**PRODUCT BULLETIN # 16734**Generic Copy

**Issue Date:** 11-Jan-2012**TITLE:** ON Semiconductor Component and Shipping Label Enhancements**PROPOSED FIRST SHIP DATE:** 13-Feb-2012**AFFECTED CHANGE CATEGORY(S):** Component and Shipping Information**FOR ANY QUESTIONS CONCERNING THIS NOTIFICATION:**

a. ON Semiconductor Standard MPN Label:

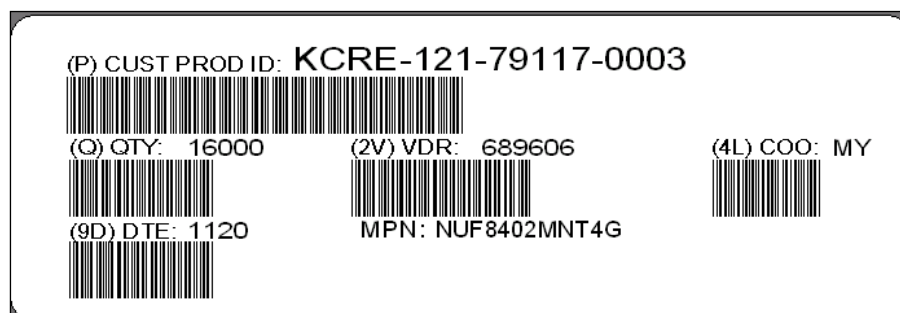
New Label Format (effective February 2012):

(When the label has expanded part number and lot number)
